ADDENDUM NO. 3

DATE: September 21, 2017
TO: All Bidders
FROM: ~~Boyce~~ H. Evans, Purchasing Agent
SUBJECT: Addendum No. 3 – North Central Street Streetscapes Project
BIDS TO BE OPENED: September 27, 2017, at 11:00 a.m. (Eastern)

STREETSCAPE IMPROVEMENTS
NORTH CENTRAL STREET
KNOXVILLE, TENNESSEE

DRAWN:	LGG
CHECKED:	ABS
JOB NO.:	51130-63
SCALE:	AS SHOWN
DATE:	06 APRIL 2017
FILE NAME:	
DRAWING TITLE:	Crosswalk Enlargements
DRAWING NO.:	L107

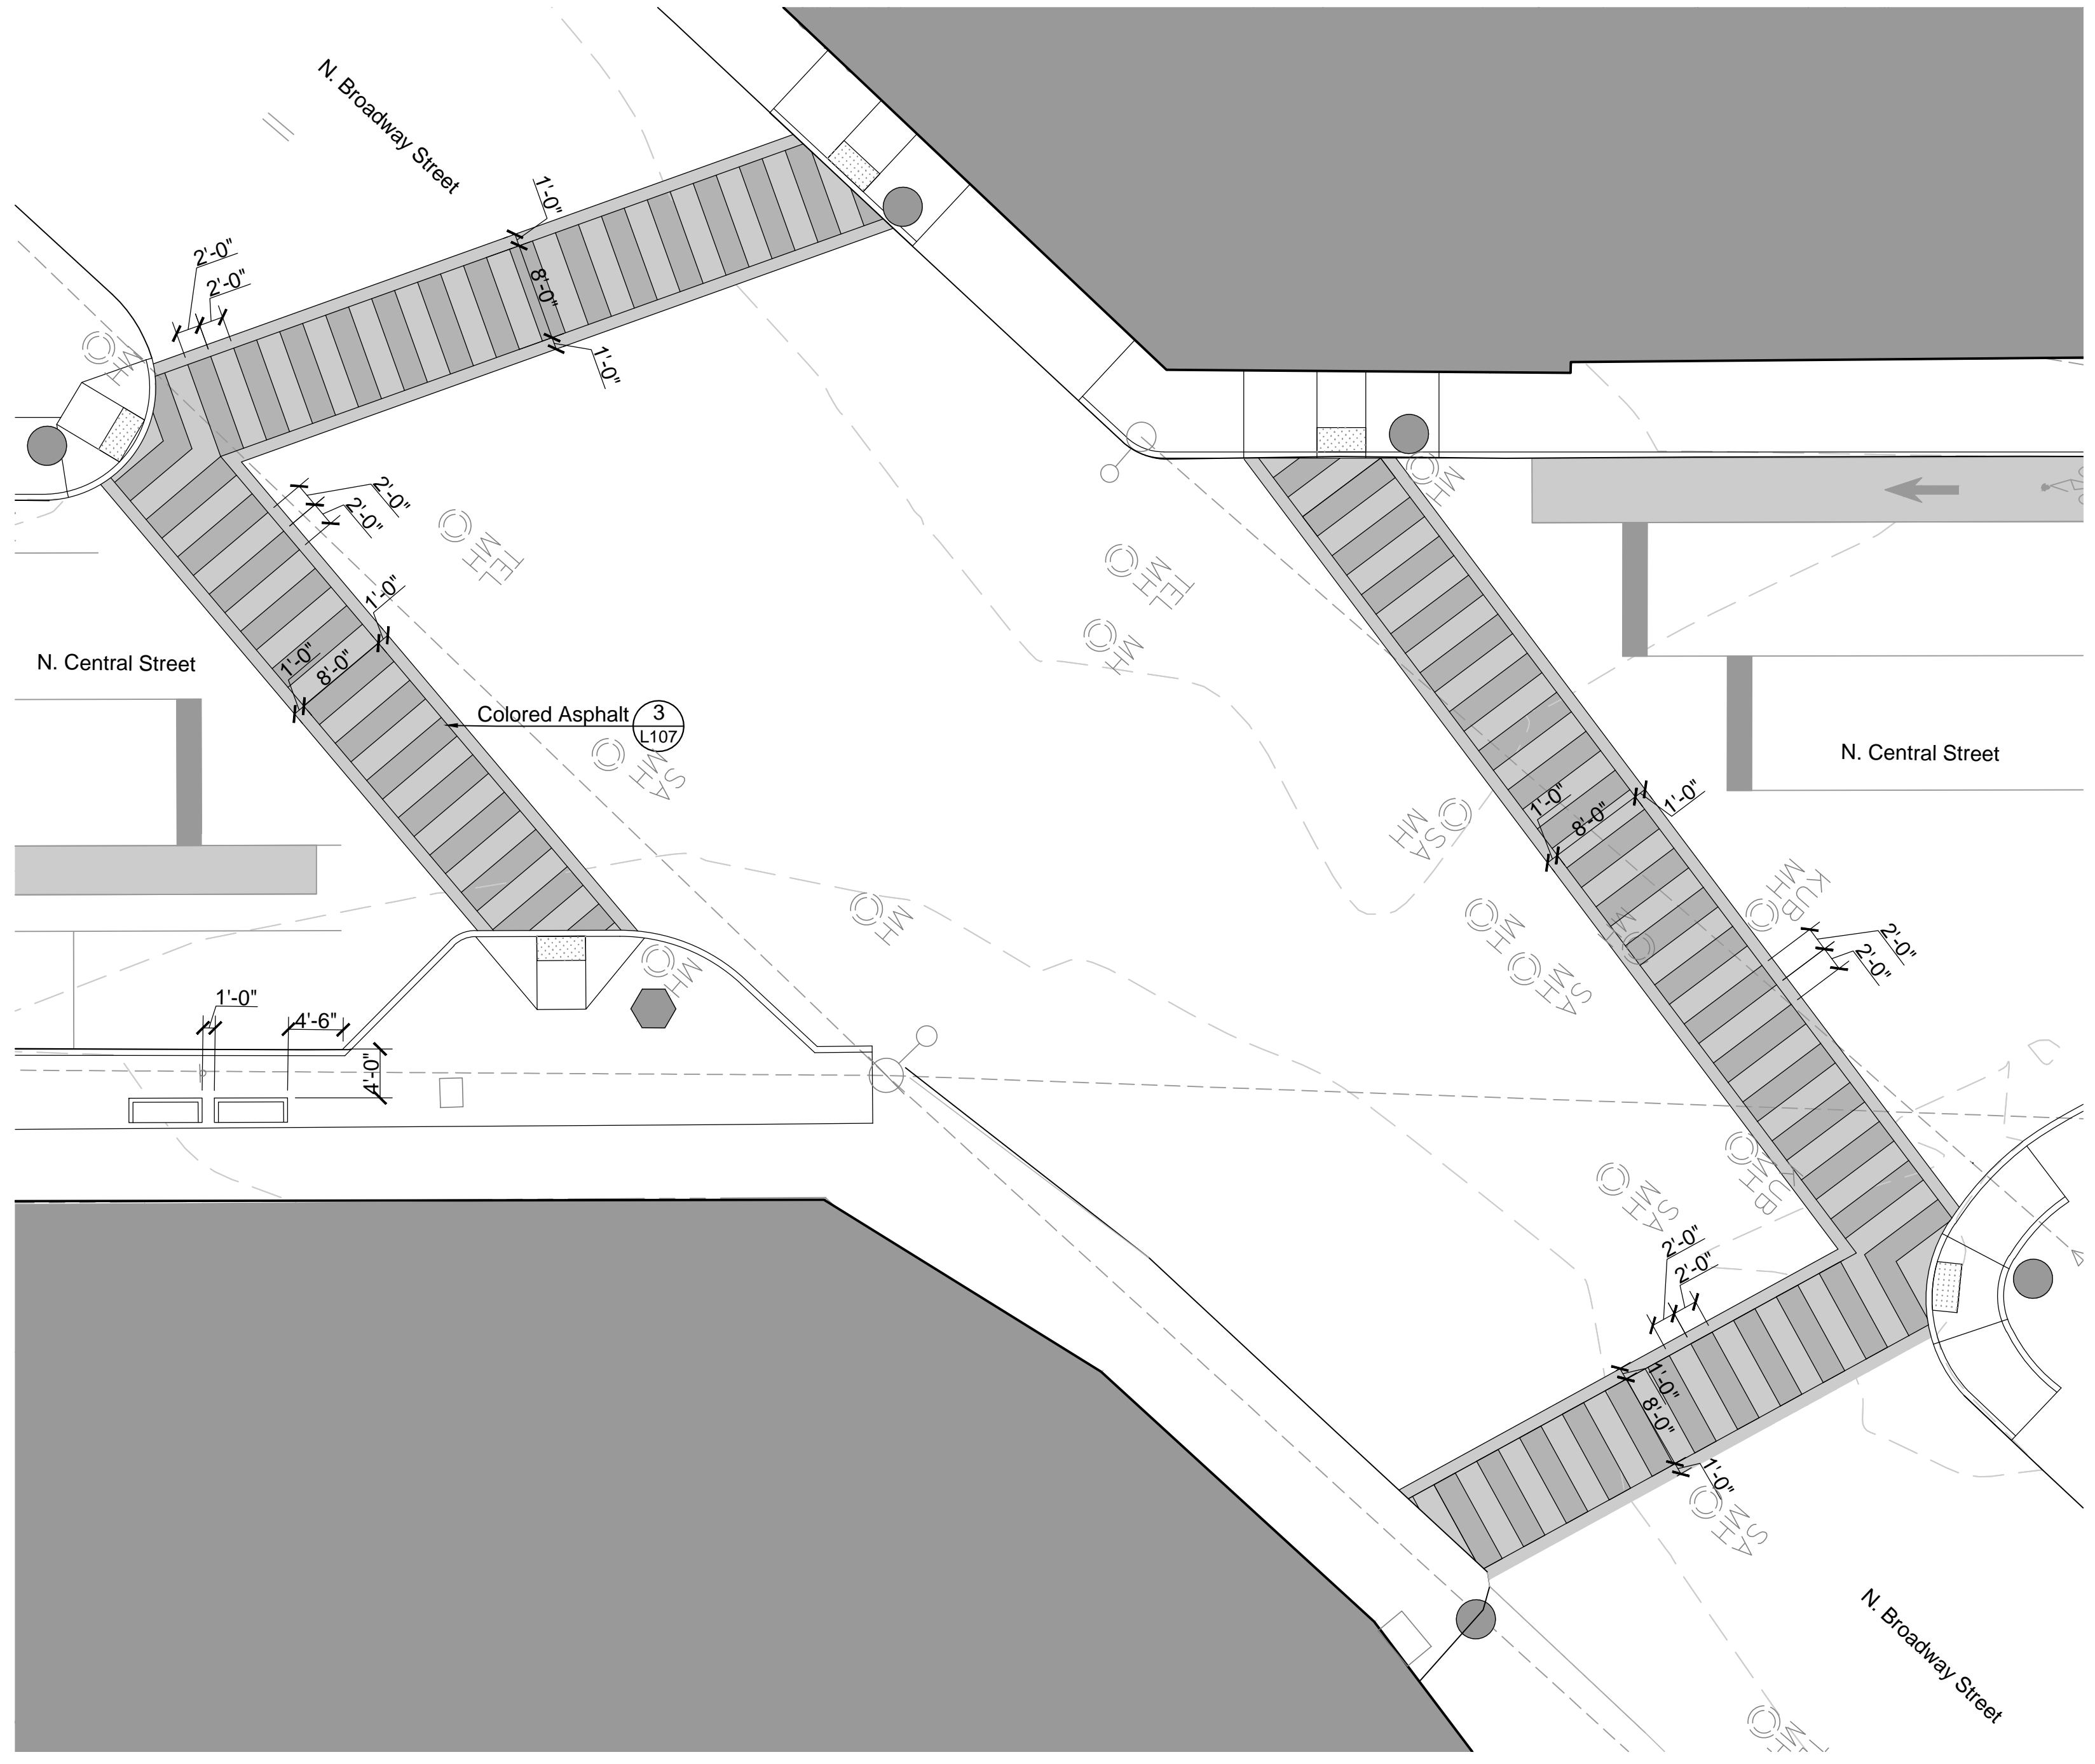
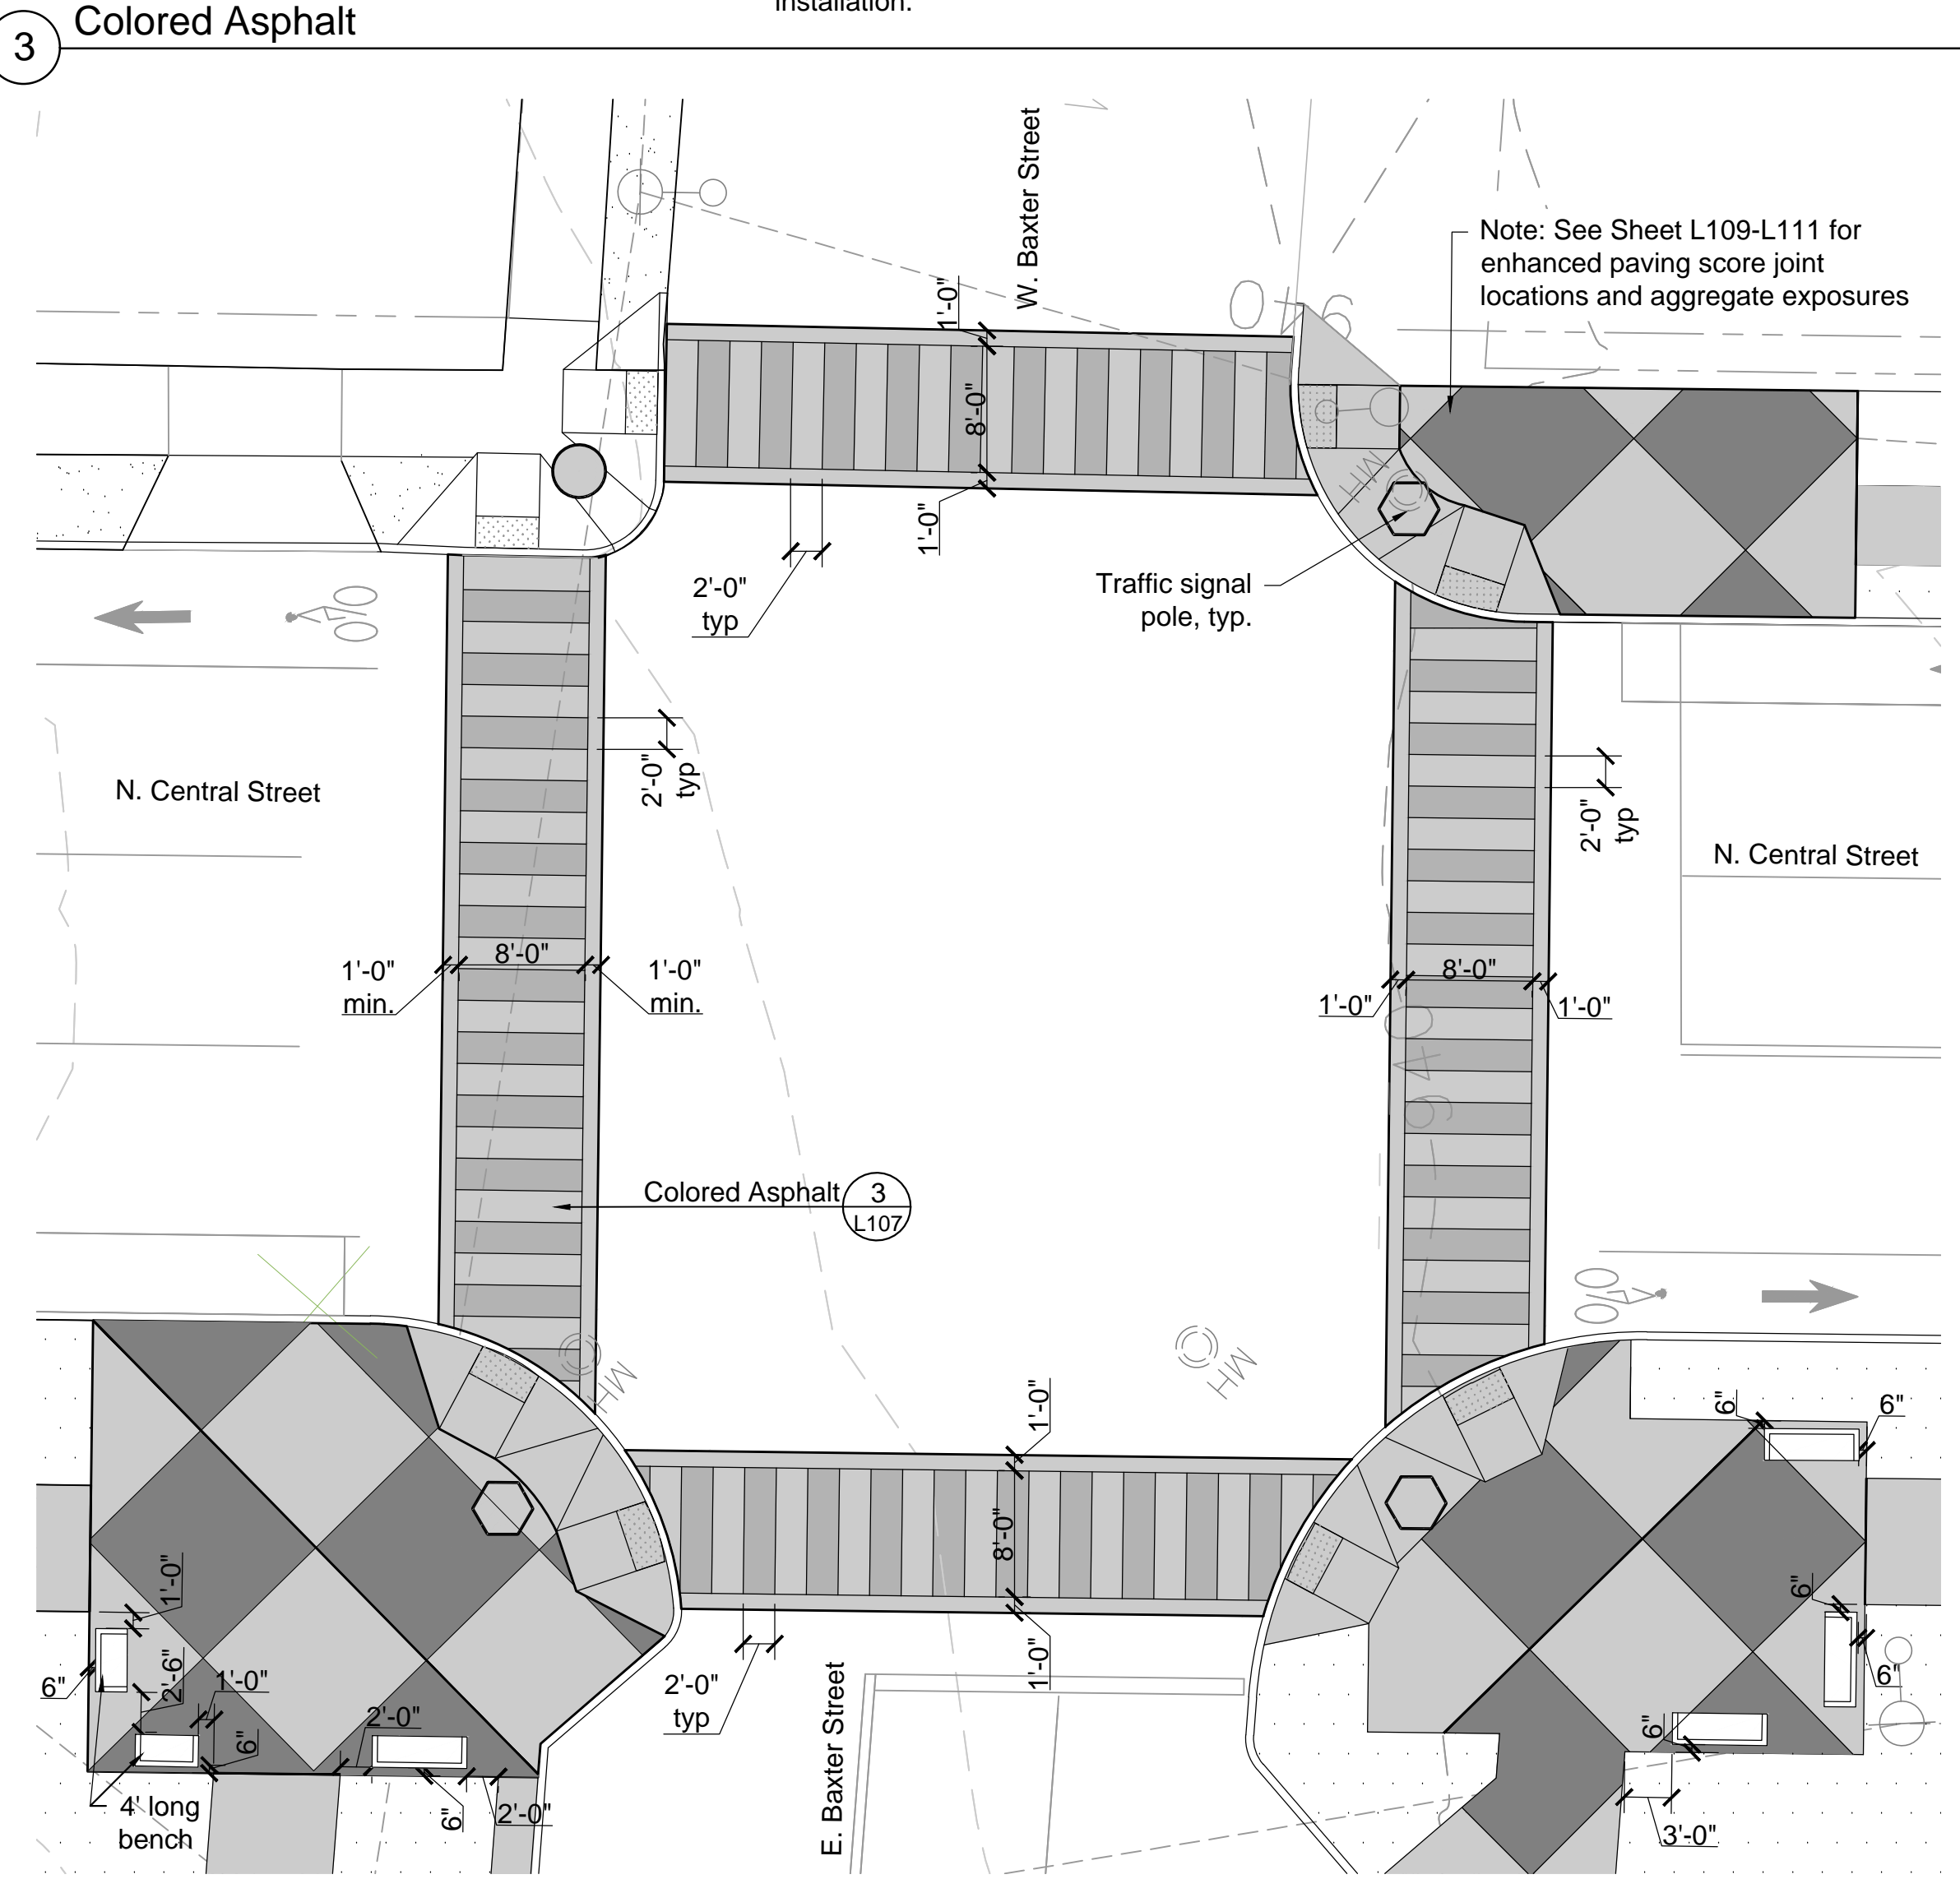
1. Referring to the Colored Asphalt detail on Sheet L107, the StreetBond and Road Color products are not acceptable alternatives to the Streetprint XD. This is now modified to state "Streetprint XD or approved equal".

NO.	DATE	DESCRIPTION
1	5.26.2017	Revised as per TDOT review comments
2	9.20.2017	Revised Colored Asphalt detail

DRAWN:	LGG
CHECKED:	ABS
JOB NO:	51130-63
SCALE:	AS SHOWN
DATE:	06 APRIL 2017
FILE NAME:	
DRAWING TITLE:	Site Furnishing Layout & Notes
DRAWING NO:	L108

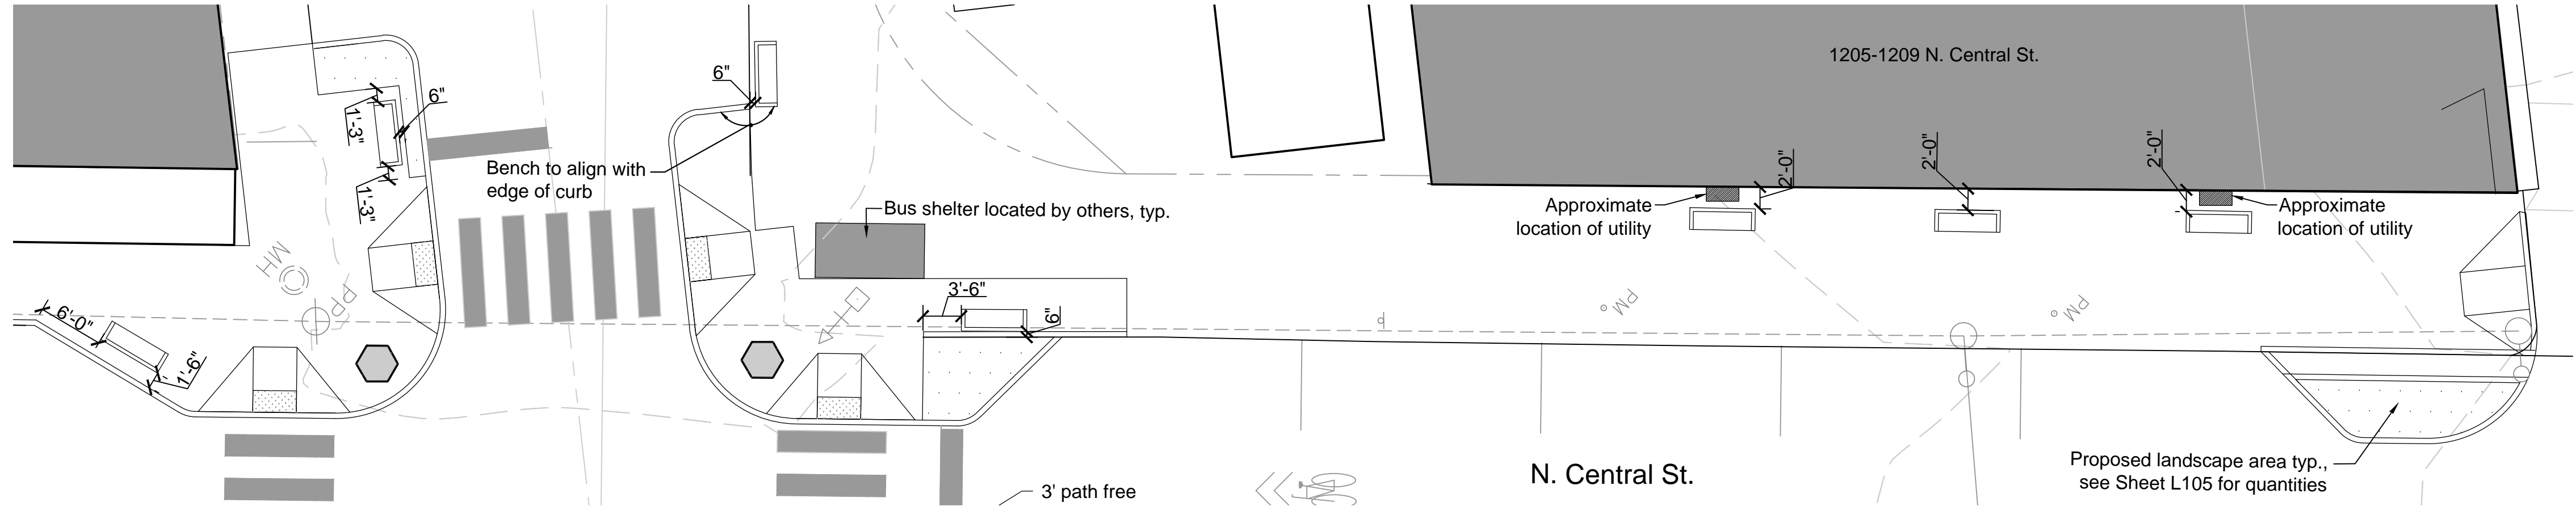
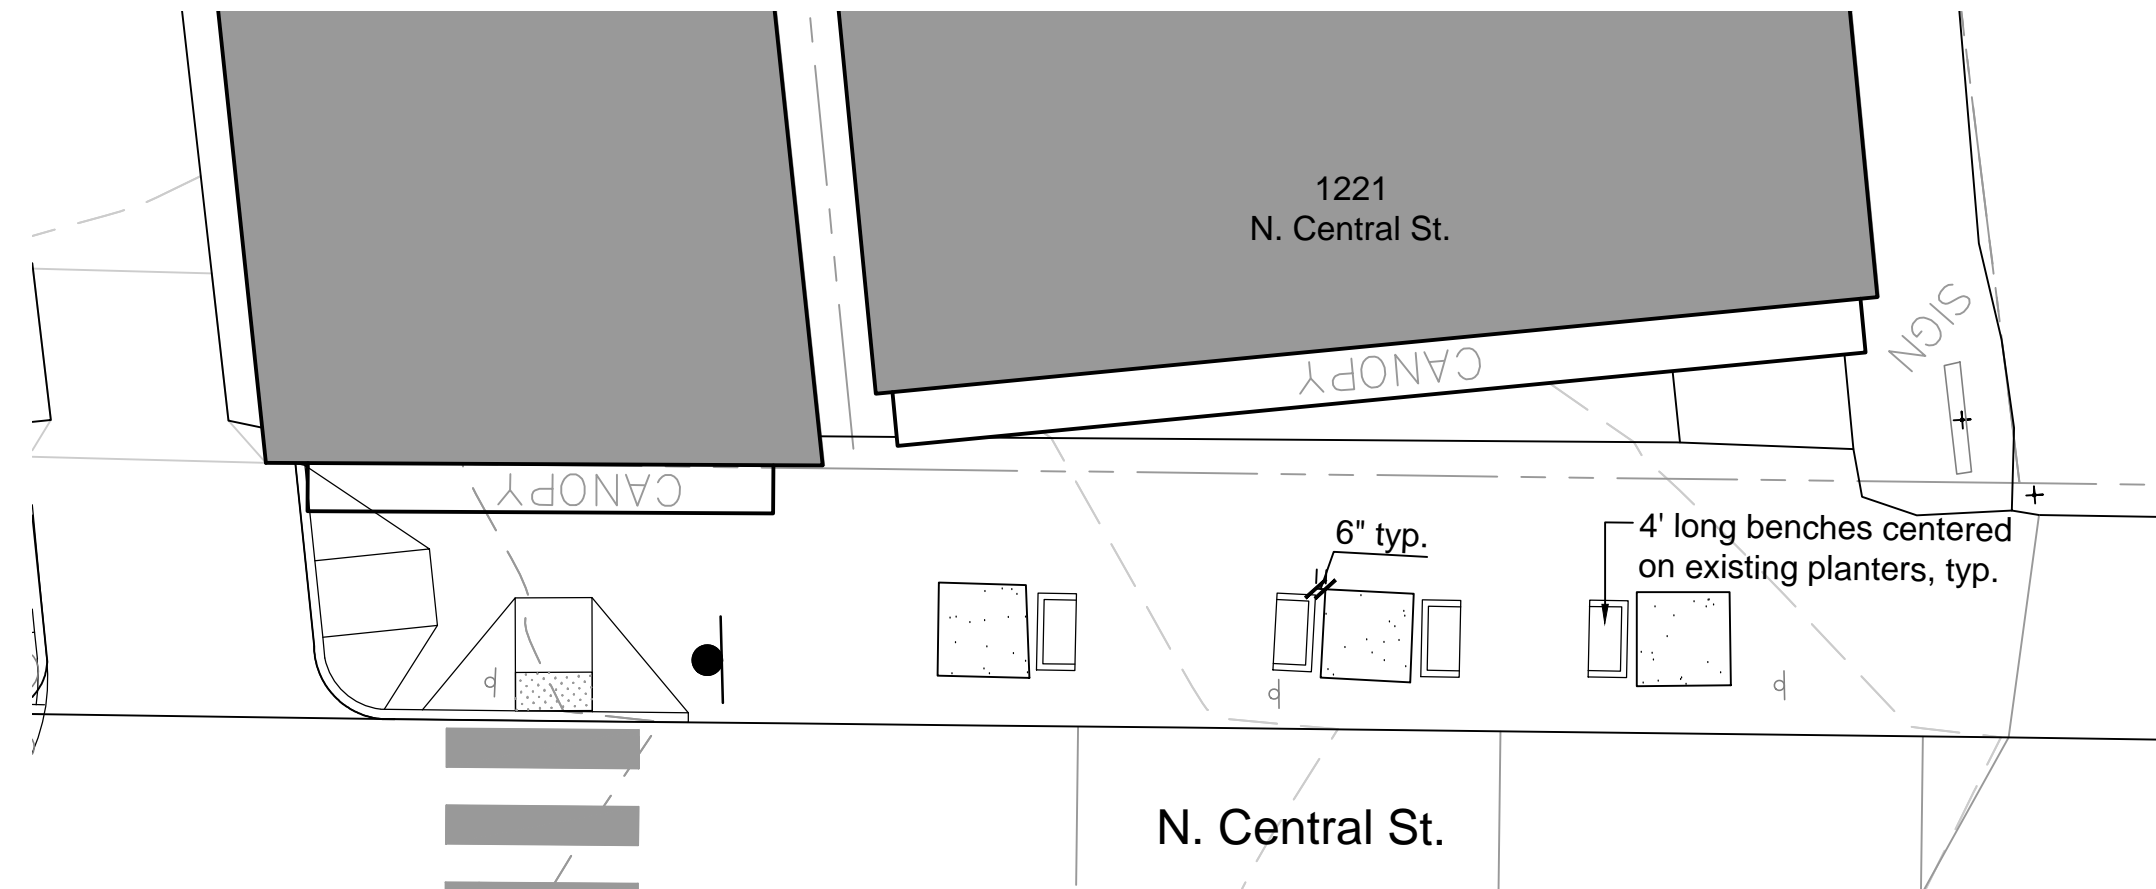
Question #15: L108 instructs the contractor to perform a percolation test of the planting areas. What is to be done if the results of this test are unacceptable?

Question #16: Please provide additional direction / specification for the following items: Sand blast finish concrete, enhanced concrete pavement.

Response #15: If the soil percolates, only one test needs to be completed. If the soil does not percolate, there needs to be another test after remediation. If it is impossible for the soil to percolate we will have to debate as a team the best solution for a particular area. Our notes on Sheet L108 state that excavation beyond 36" needs to be done to a point of percolation. This is paid for under Item 920-10.03, Planting Soil.

Response #16: Section 321313, Concrete Paving, covers enhanced concrete, both the sand blasted finish and broom finish. Subsection 2.1B is "Exposed Aggregate" and 2.1C specifies "Fine Aggregates" for the sand. Section 3.7 "Finishing" includes language for a light broom finish, but does not specify the sand blasting. Sand Blasting Notes on Sheet L108 specify "Medium Sand Blast Finish: generally expose coarse aggregate: 3/16" to 1/4" reveal". A plan revision is included with this addendum that removes "HS- Heavy Sand Blast Finish". "MS- Medium Sand Blast Finish" has been revised to "SB-Sand Blasted Concrete" to match the legend and text on the plans. The reveal will remain 3/16"-1/4".

- Finish Description
EP- Enhanced Paving, provide light broom finish.
SB- Sand Blasted Concrete: generally expose coarse aggregate: $\frac{3}{16}$ " to $\frac{1}{4}$ " reveal.
- Mock-Up Descriptions
Provide (3) mock-ups for each finish with jointing for enhanced paving. Mock-up size is to be 4' x 4' in size & include materials and methods used to produce each finish for review & approval. Review will be for color, texture, and jointing. Approved samples will become the control sample.
